# Comhairle Chontae Atha Cliath Theas

## Record of Executive Business and Chief Executive's Order

**Reg. Reference:** SD22A/0398      **Application Date:** 24-Oct-2022  
**Submission Type:** New Application      **Registration Date:** 24-Oct-2022

**Proposed Development:** Construction of a three storey creche and community  
centre facility of 1, 610sq.m gross floor area with  
associated external play area; car & cycle parking,  
hard and soft landscaping, bin storage, a revised layout  
to the northern edge of Cuil Duin Avenue to  
accommodate access to the proposed development  
including amendments to the existing footpath and  
cycle track and provision of set down car parking  
spaces and all associated site and development works.

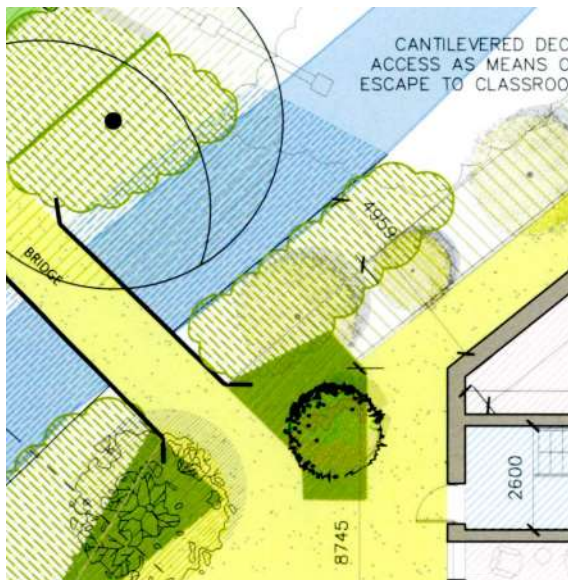
The proposed dual use building now designed as a three storey building will be L-shaped at first and second floor (where the community centre will be located) to address the principle street/adjacent buildings. A west facing external roof deck with green roof at first floor level will provide for recreational use for community groups. Regarding elevational treatment a contemporary palette of materials are proposed, and the applicant has submitted proposed CGIs (Computer Generated Images) which integrate well with the character of the area and address the street in a positive manner. However, a separation distance of only c.20.5m will be provided for between directly opposing above ground floor windows on the southern elevation whereby the proposed development would face directly onto the existing houses on Cuil Duin Avenue. To comply with the SDCC Development Plan 2022-2028 (Sc.12.6.7 Residential Standards, Separation Distances and Block Layout) a separation distance of 22 metres should be provided for all residential

developments between directly opposing above ground floor windows. Notwithstanding this as the proposal is not a residential development and existing residents in Cuil Duinn Avenue would be expected to have reasonable levels of privacy with the proposed development this shortfall in separation distance would be acceptable in this instance.

The proposal includes for a direct connection to a 30sq.m. pocket park which will be accessed via a pedestrian foot bridge over the existing stream. However, the Planning Authority have serious concerns regarding the footprint of the proposed development being located c.5 metres from the adjacent watercourse which runs along the north-west of the subject site. *Section 12.4.3 Riparian Corridors* of the SDCC Development Plan 2022-2028 states that Development within or affecting riparian corridors will be required to:

The applicant should be requested to address the shortfall in setback by way of **additional information** and submit revised drawings re-siting the proposal and pulling the proposed structure back to a minimum of 10 metres from the adjacent stream. The applicant should also provide for appropriate landscaping and planting for biodiversity within the 10 metre buffer zone.
